STATE OF CALIFORNIA - DEPARTMENT OF TRANSPORTATION
ENGINEER'S DAILY REPORT
 LAN Engineering Consultant

04-SF-80-13.2/13.9
 Contract No. 04-0120F4
 {SAS Superstructure}

❖ **Submittal NO. ABF-SUB-000235 Rev: 0**

Subject: Elevator Layouts, Electrical Schematics, and Hoist Calculations.

DRAWING NUMBER:	L941301A
DRAWING DATE:	JULY 2, 2007
DRAWN/ENGINEER:	PP/PP
CONTRACT NUMBER(S):	L9413

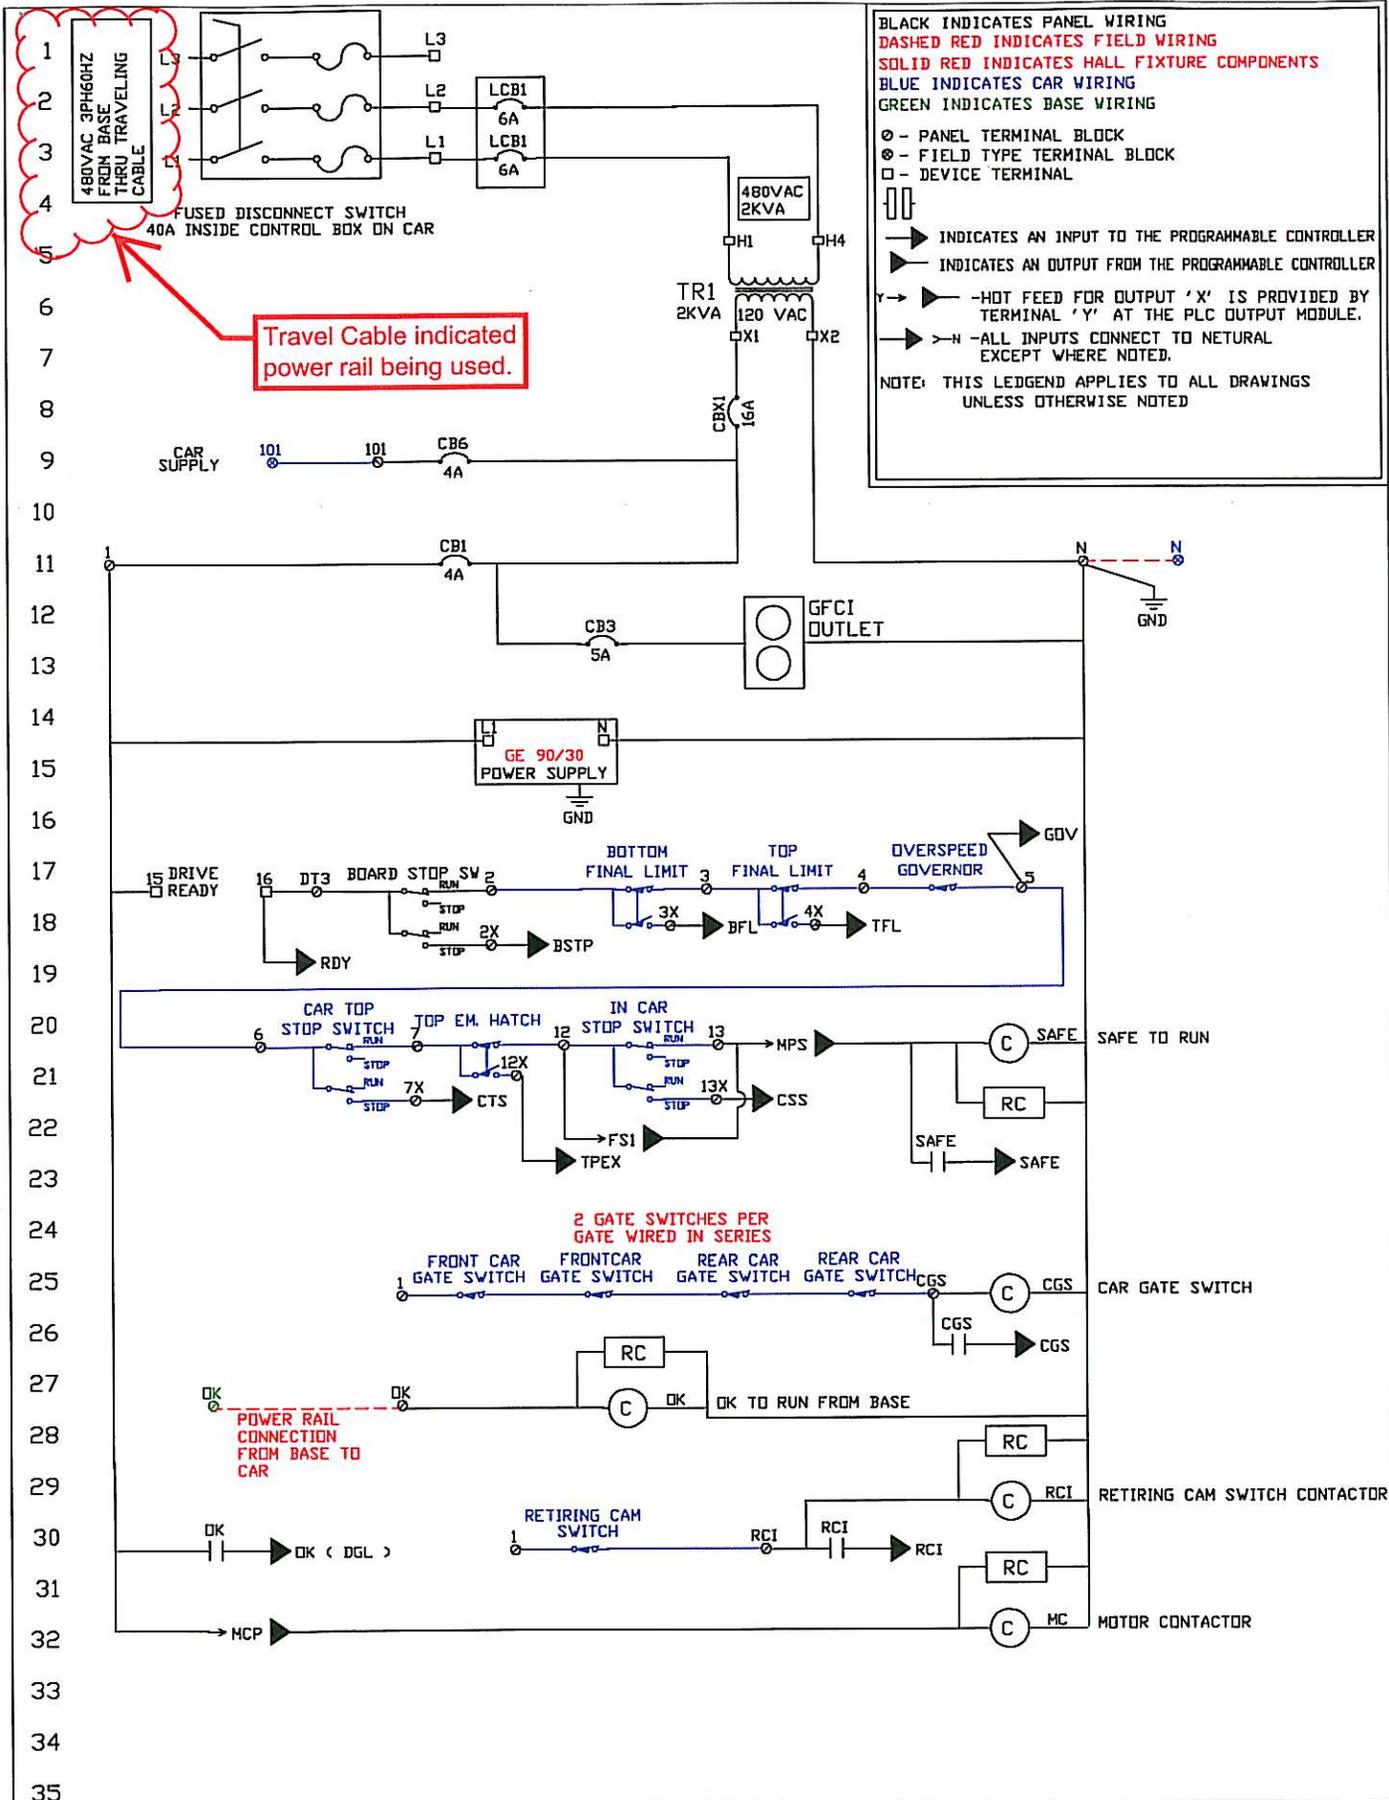
Travel Cable indicated power rail being used.

- Electrical Schematic Package
 - Drawing L941301A:
 - Comments:
 - Travel Cable indicated – Power Buss being used? Conflict in plans.

DRAWING NUMBER:	L941310A
DRAWING DATE:	JULY 3, 2007
DRAFTER/ENGINEER:	PP/PP
CONTRACT NUMBER(S):	L9413

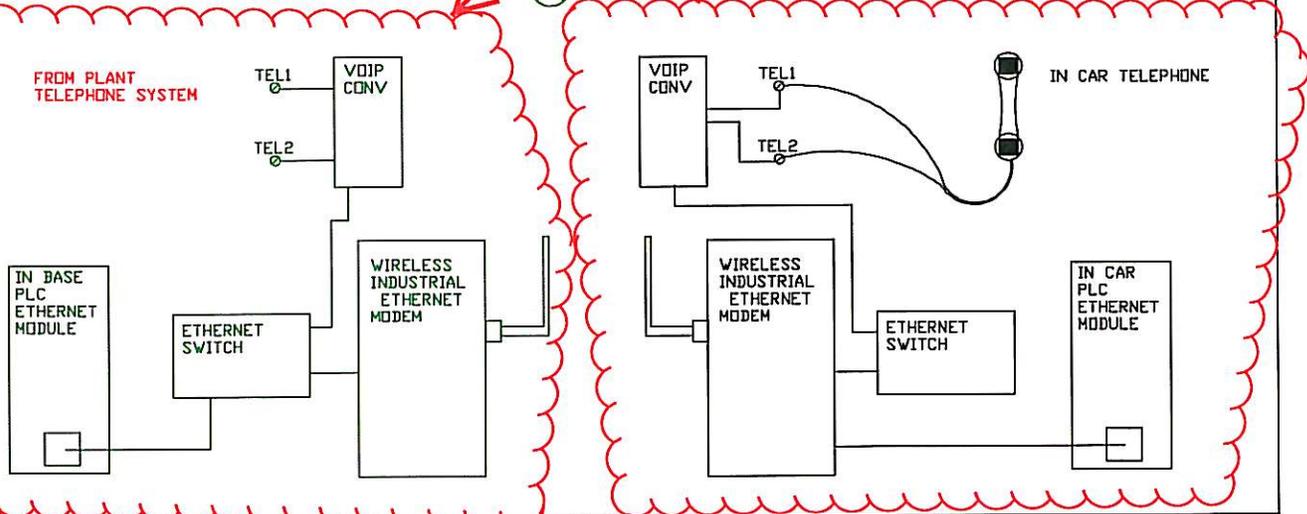
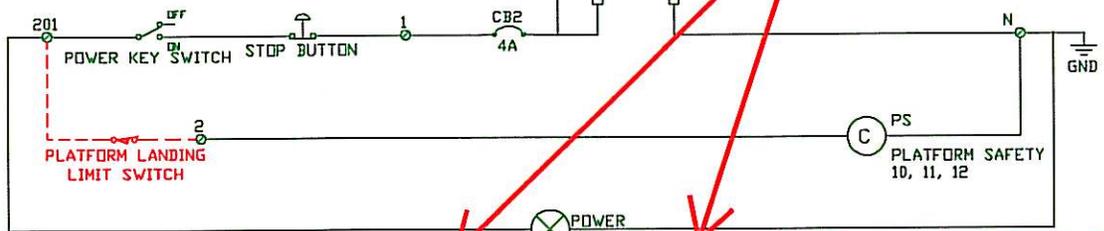
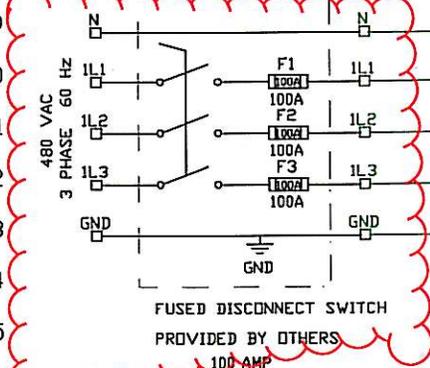
* 20A circuit breaker provided

*Drawing error

* 100A circuit breaker provided.
 * neutral required ?

*Emergency power back-up provided for unit?
 *Unit approved by governing Authority?
 * Unit compatibly to communication system?
 * Location of equipment?

- Drawing L941310A:
 - Comments:
 - 20A Circuit Breaker being provided per contract plans (16A Fusible indicated in submittal).
 - 100A Circuit Breaker being provided per contact plans (100A Fusible indicated in submittal).
 - Submittal indicates a Neutral being required (Need to provide neutral conductor in contract).
 - Drawing error identifying a neutral for a 120volt circuit.
 - Information missing on the Phone System in the submittal.
 - Emergency power back-up system not indicated.
 - Unit shall be approved by Governing Authority.
 - Unit shall be compatible with the communication system in the contract.
 - Location of equipment is not shown on the plans.

DRAWING NUMBER:	L941311A
DRAWING DATE:	JULY 2, 2007
DRAWN BY/ENGINEER:	PP/PP
CONTRACT NUMBER(S):	L9413

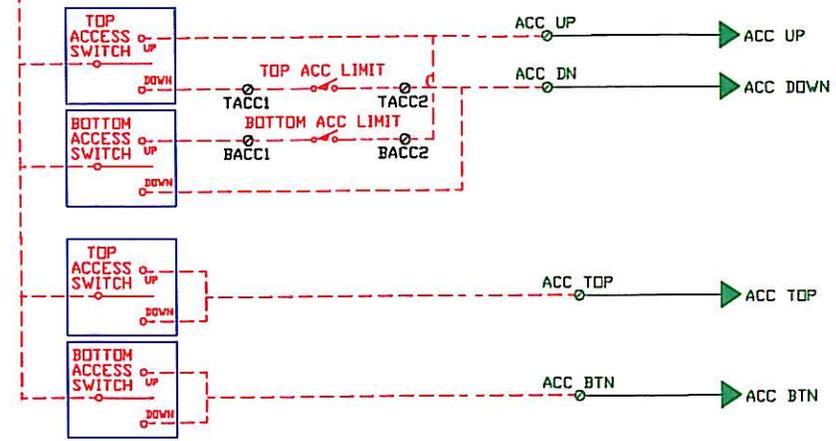
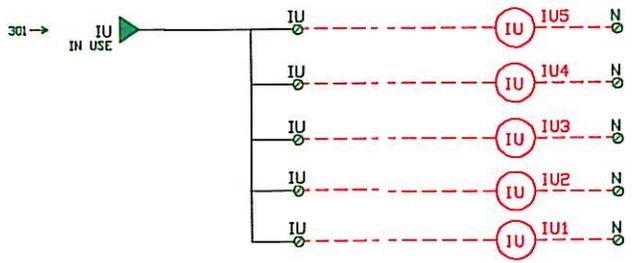
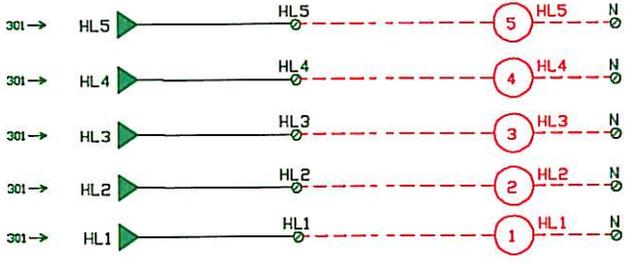
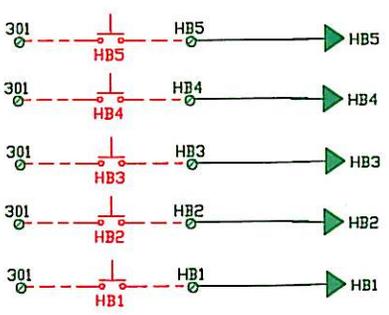
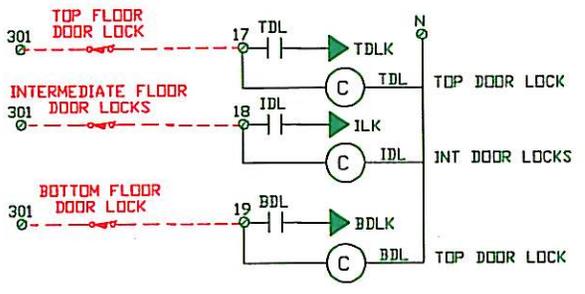
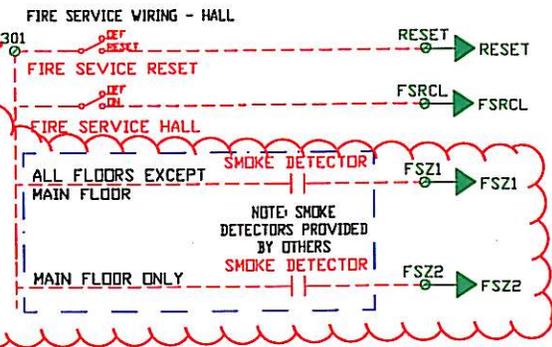
* Smoke detectors required for this type of elevator?

- Drawing L941311A:
 - Comments:
 - Smoke detectors are shown on the submittal but are they required for this type of elevator? The elevator is located outside in open air.
- Drawing L941311A:
 - Comments:
 - Smoke detectors are shown on the submittal but are they required for this type of elevator? The elevator is located outside in open air.

DRAWING NUMBER:	L941313A
DRAWING DATE:	JULY 3, 2007
DRAFTER/ENGINEER:	PP/PP
CONTRACT NUMBER(S):	L9413

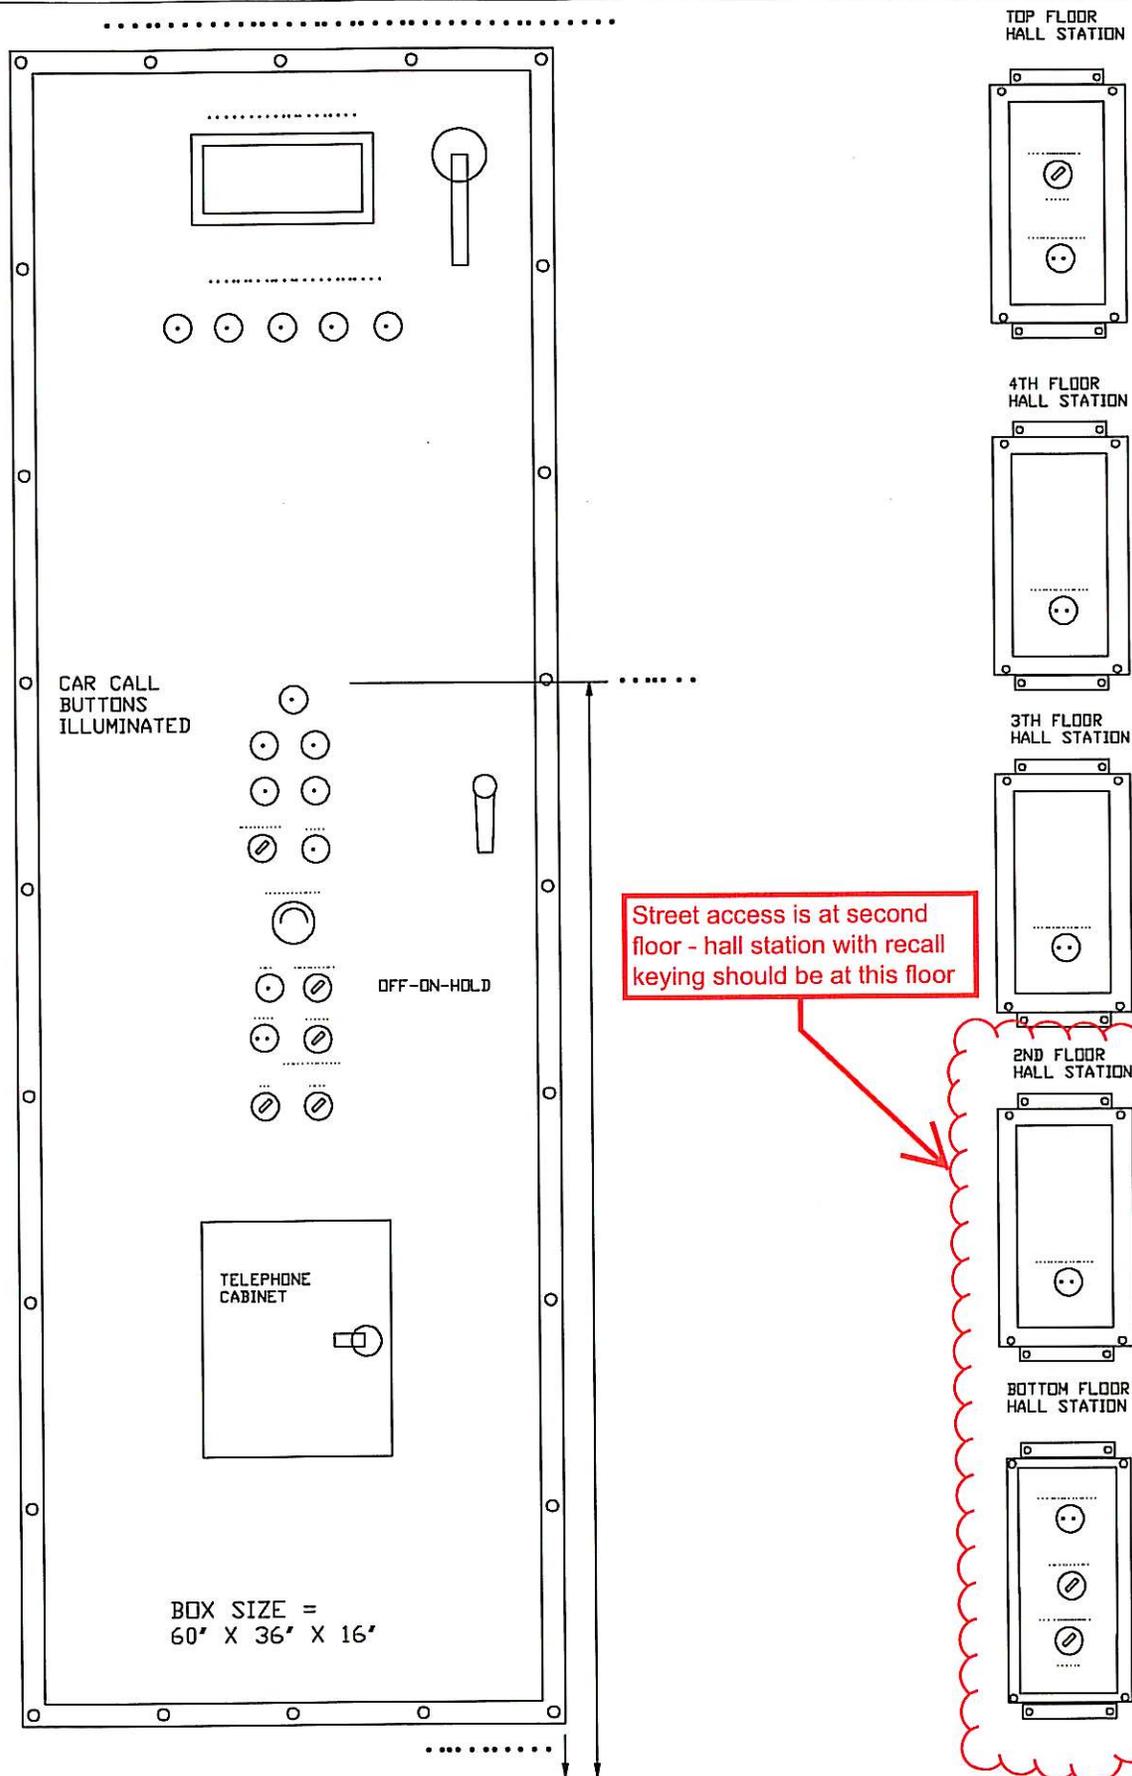
- Drawing L941313A:
 - Comments:
 - The submittal shows the hall station with the recall keying and emergency items at the bottom floor. The bottom floor is not the street access (Lobby) level for the elevator. The second floor is at elevation of the roadway access. I believe the hall station for access to emergency personnel would be at the second floor.
